From: Westrom, Ryan (DDOT) [ryan.westrom@dc.gov]
Sent: Tuesday, March 17, 2015 11:28 AM
To: 'Juan Cameron'; Marcou, Matthew (DDOT); Richards, Laura (DDOT); Edwards, Bernadette (DDOT); 'bill.starrels@gmail.com'; 'vrixey@cagtow.org'
Cc: Jami L. Milanovich (jlmilanovich@mjwells.com); Amelia R. Martin (ARMartin@mjwells.com); Roddy, Christine; Travis Westmoreland; Morgan Ziegenhein; Dan McCaffery; bircht@earthlink.net
Subject: RE: Prospect Meeting yesterday with DDOT re 3220 Propsect Street.
Attachments: 1930_001.pdf

Board of Zoning Adjustment
District of Columbia
CASE NO.18977
EXHIBIT NO.25A

Subject: Prospect Meeting yesterday with DDOT re 3220 Propsect Street.

Proposed Prospect Concept

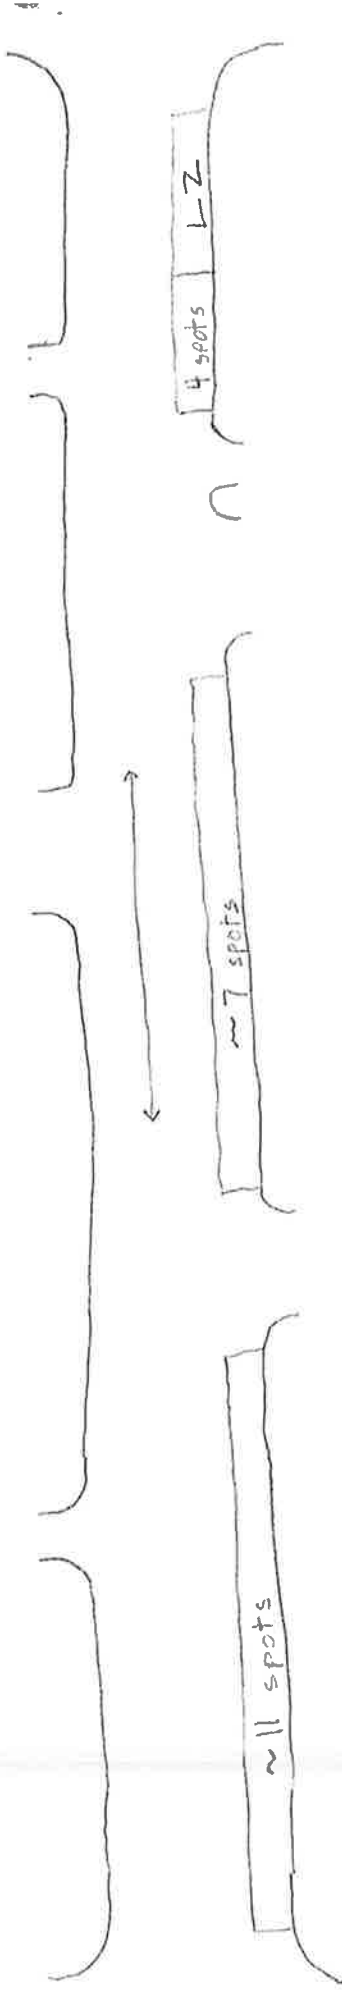
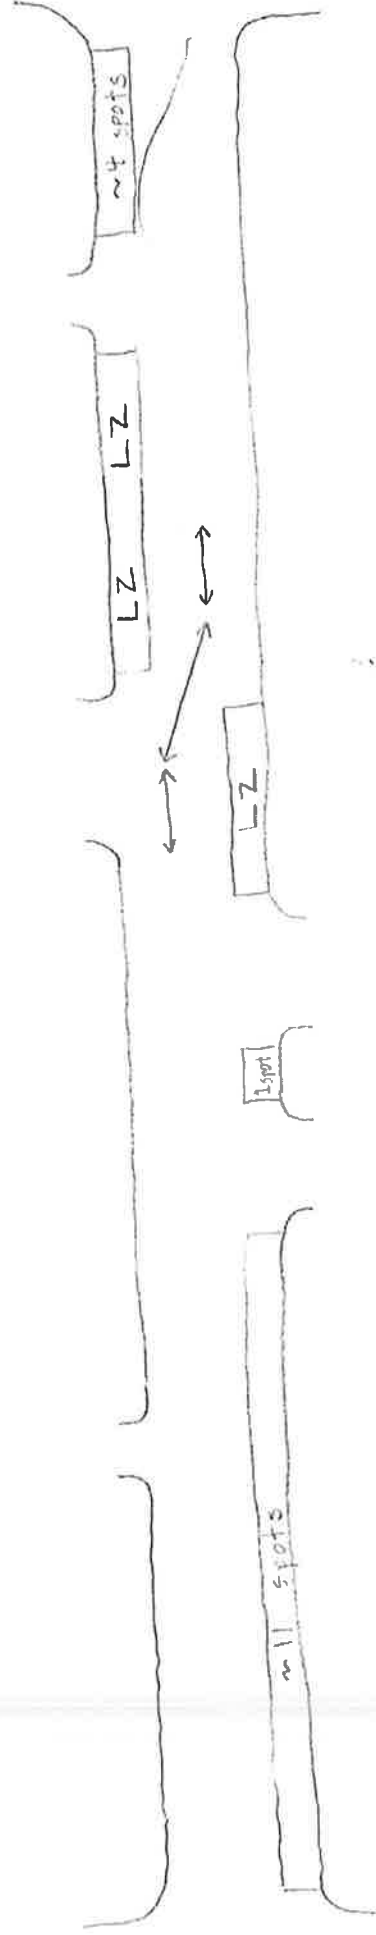
The second issue is around where to put the additional on-street loading space. During our on-site meeting we considered potential street layout in light of the loading needs. (As requested, we did prepare the attached conceptual sketch of what this could look like, however this does not imply ultimate DDOT support for this concept.) While a solution which jogs parking from one side of the street to the other may be a workable solution, this is not a decision to be made now. DDOT also notes that such an alignment has potential safety concerns due to traffic travel in opposite directions in what would amount to the same lane. We are not certain this is a layout that would be acceptable to DDOT.

Existing Prospect

~22 parking spots
~45' loading zone

~16 parking spots
~100' loading zones

At this point, we believe that a commitment from the Applicant to work with DDOT towards an on-street loading solution is needed. The demand for additional loading space should be defined in the BZA process and the CTR should be updated to include this discussion. Once the project moves into the permitting process, if there is a preferred or recommended street layout, the Applicant should propose this, including specifics on exactly what length of loading zone should be included. DDOT anticipates being generally supportive of the zoning action sought, but would reserve full review on design details until the public space permitting stage of the process.
